**LEXINGTON-FAYETTE URBAN COUNTY GOVERNMENT
CONTRACT CHANGE ORDER**

Date:	October 14, 2016
Project:	Roof Replacement - Government Center and Arts Place
Location:	200 East Main St and 161 N Mill St
Contract No.	265-2015
Original Contract Amt.	\$702,690.00
Cumulative Amount of Previous Change Orders	\$3,446.00
Percent Change - Previous Change Orders	0.49%
Total Contract Amount Prior to this Change Order	\$706,136.00
Change Order No.	2

JUSTIFICATION FOR CHANGE

PROJECT: Roof Replacement - Government Center and Arts Place

ROOF EDGE

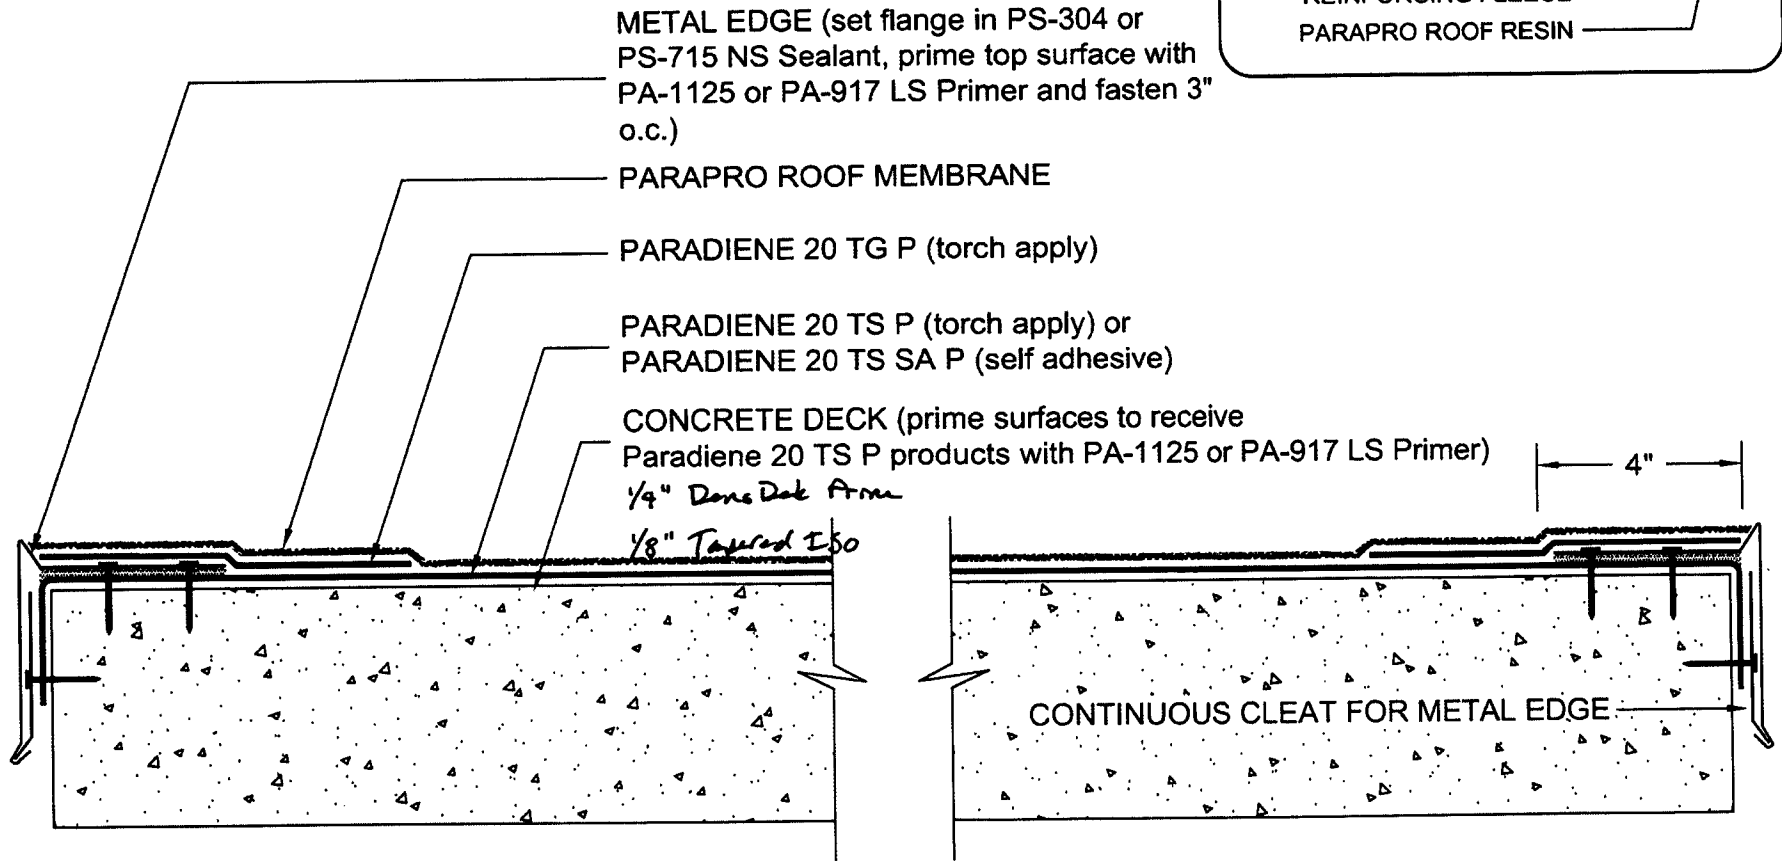
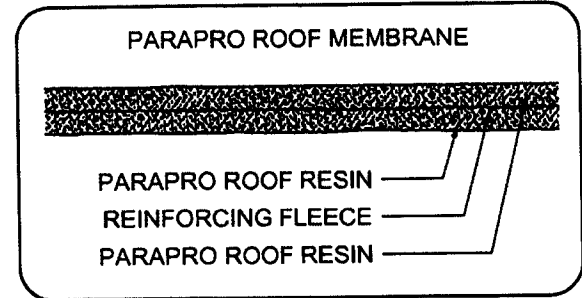
As we've discussed removing the existing roof on the Gov't Center fire escape platform and installing a new Siplast roof system is necessary.

Remove the existing roof and safety screen, dry and prepare the deck before setting 1/8" tapered ISO in low rise adhesive, 1/4" Densdek prime in low rise adhesive, Siplast's P20 SA Base Sheet, followed by Siplast's Parapro Roof Membrane. Additionally, metal edge will be installed around the perimeter to cover the existing vertical wall flashing. If the existing wall height will allow, we will install a reglet mounted two piece wall flashing. If the existing wall height does not allow, we will work with Siplast on a detail that meets their 20 year roof warranty specification.

Jim / Jessica: I recommend approval of Tri-States request for \$5,990,00 to perform the additional work enumerated in his message below.
